## Modification of RX-Audio-Response for 7-Line (TR7 and R7)

### Introduction

Picture 1 AF-Response of TR7 and R7 before and after Modification

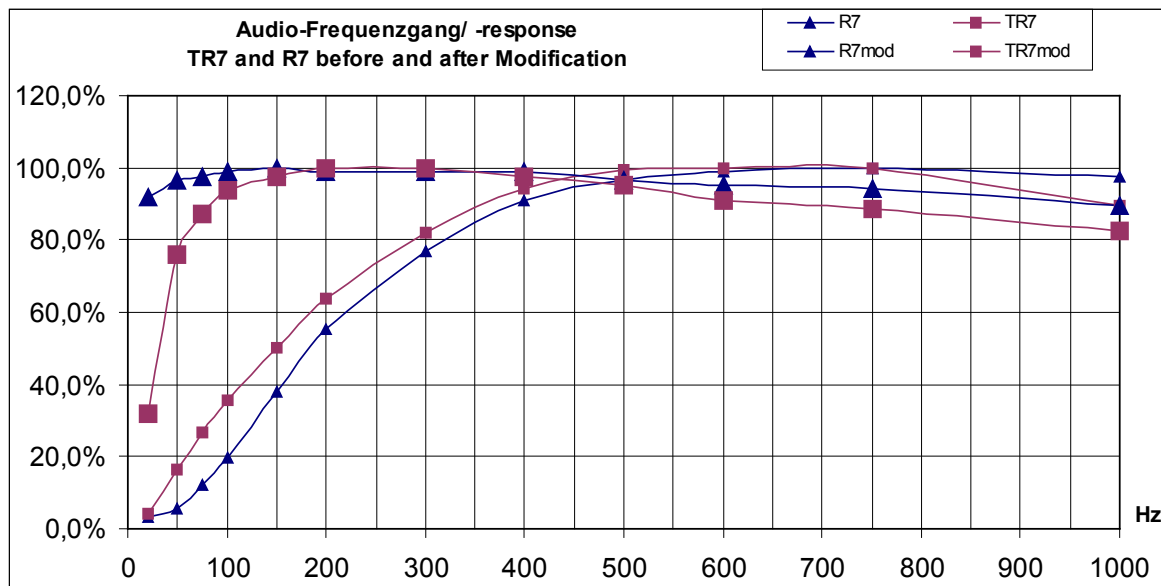
Result: A strong damping of frequencies below 400Hz can be seen in picture 1 (curves with small dots). The y-axis is calibrated in  $mV_{rms}$ , and related in percentage to the maximum voltage within the range of frequencies.

Reason: Examining the AF-circuits, it can be seen, that there are coupling capacitors, which are too small. Increasing these capacitors solve this problem.

The modifications described in this article lead to the curves with the big dots in picture 1. All capacitors with 0,47uF are non polarised/monolithic; capacitors with 4u7 or bigger are electrolytic (observe polarity!).

Picture 2 Modified C's on the TR7 – 2<sup>nd</sup> IF/Audio Board

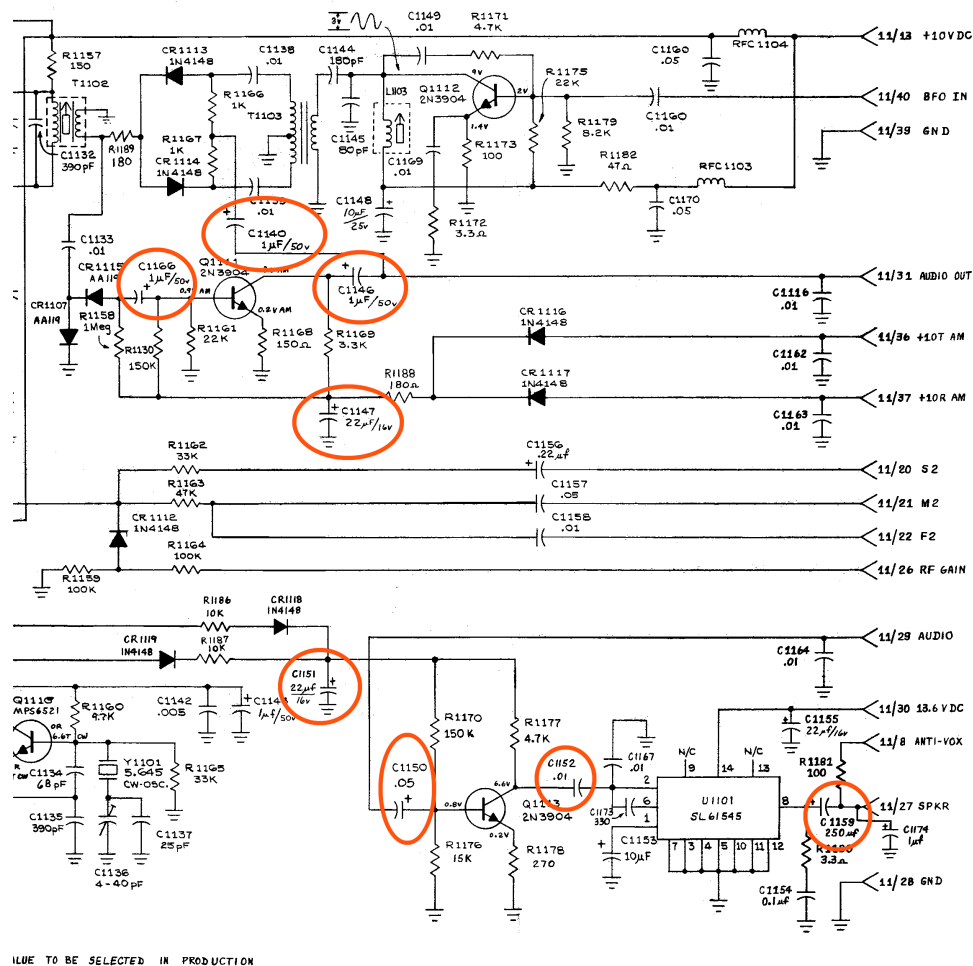
Table 1, Picture 2 and 3 show the modified C's on the TR7's board „2ndIF/AGC“ and the locations.

Capacitor	Old value	New value
C 1140	1uF	4u7 or 10uF/15V
C 1146	1uF	4u7 or 10uF/15V
C 1147	22uF	100uF/25V
C 1150	0,05uF	0,47uF
C 1151	22uF	100uF/25V
C 1152	0,01uF	0,47uF
C 1159	250uF	1000uF/25V
C 1166	1uF	4u7 or 10uF/15V

Picture 4 Modified C's on the R7 - Audio/PTO Buffer

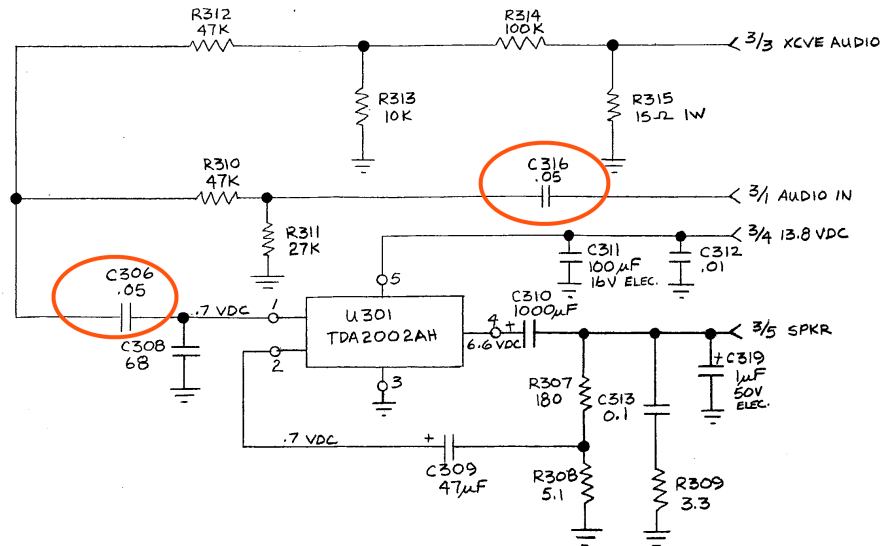
Table 2, Picture 4 and 5 show the modified C's on the R7's board „Audio/PTO Buffer“ and the locations.

Capacitor	Old value	New value
C 306	0,05uF	0,47uF
C 316	0,05uF	0,47uF

Picture 6 Modified C's on the R7 - 2<sup>nd</sup>/3<sup>rd</sup> IF/AGC Board

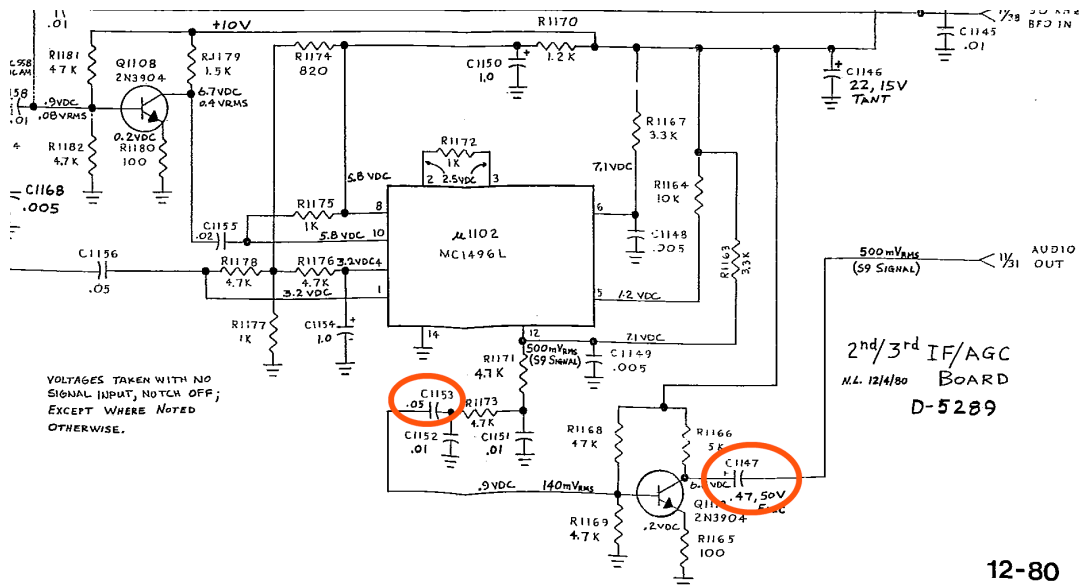
Table 3, Picture 6 and 7 show the modified C's on the R7's board „2<sup>nd</sup>/3<sup>rd</sup> IF/AGC“ and the locations.

Capacitor	Old value	New value
C 1147	0,47uF	10uF/63V
C 1153	0,05uF	0,47uF
